LEE'S SUMMIT
MISSOURI
Development Services Department

Development Services Staff Report

File Number	PL2023-339
File Name	PRELIMINARY DEVELOPMENT PLAN – Summit Orchards North
Applicant	Townsend Capital, LLC
Property Address	1151 NW Ward Rd, 1201 NW Ward Rd and 1231 NW Ward Rd
Planning Commission Date Heard by	February 22, 2024 Planning Commission and City Council
Analyst	Hector Soto, Jr., AICP, Senior Planner

Figure 3 - Profile of I-470 relative to auto dealership monument sign locations

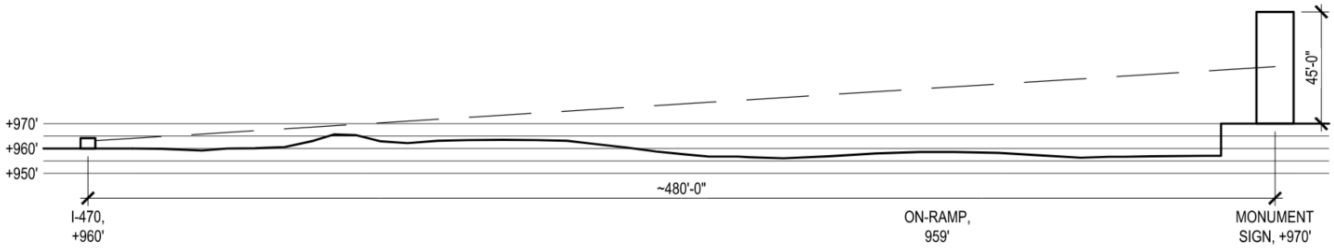
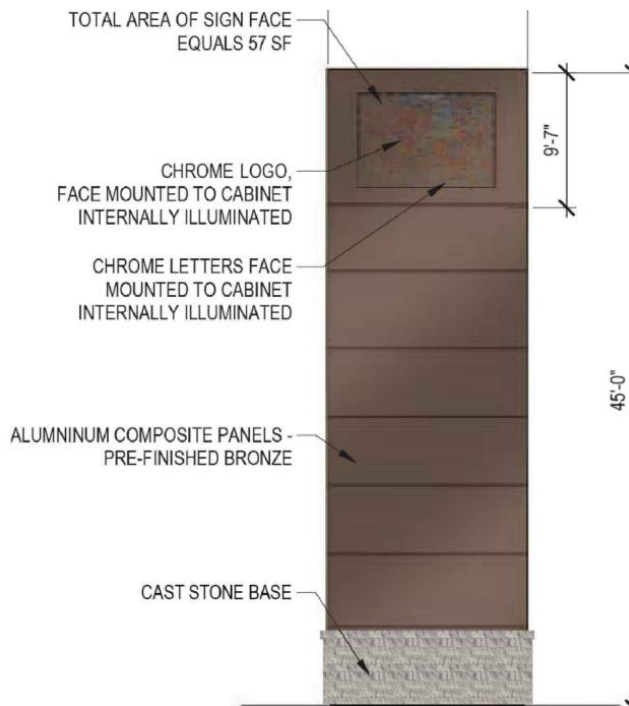
As it relates to monument signs, the applicant proposes an allowance for each of the two auto dealership sites to have one monument sign along its respective I-470 frontage for a 45’-tall sign with a total structure area of 637.5 sq. ft. compared to the UDO’s typical standard of 12’ height and 96 sq. ft. total structure area. The rationale for the allowance for taller and larger signs for the auto dealership sites is related to the grade differences and distance between the I-470 travel lanes and the project sites. There is a grade difference of

10' between the I-470 travel lanes and the monument sign locations. This condition taken in conjunction with the approximately 480' of horizontal separation between the travel lanes and sign locations provides a practical difficulty in providing reasonably visible signage along I-470 in strict adherence to the UDO standards for a monument sign. Staff supports the applicant's proposal for taller and larger monument signs along the I-470 frontage for the auto dealerships as depicted in the preliminary development. The applicant has provided a profile of the site to illustrate the grade difference and horizontal separation. The proposed signs will, however, comply with the allowable sign face standard of 72 sq. ft.
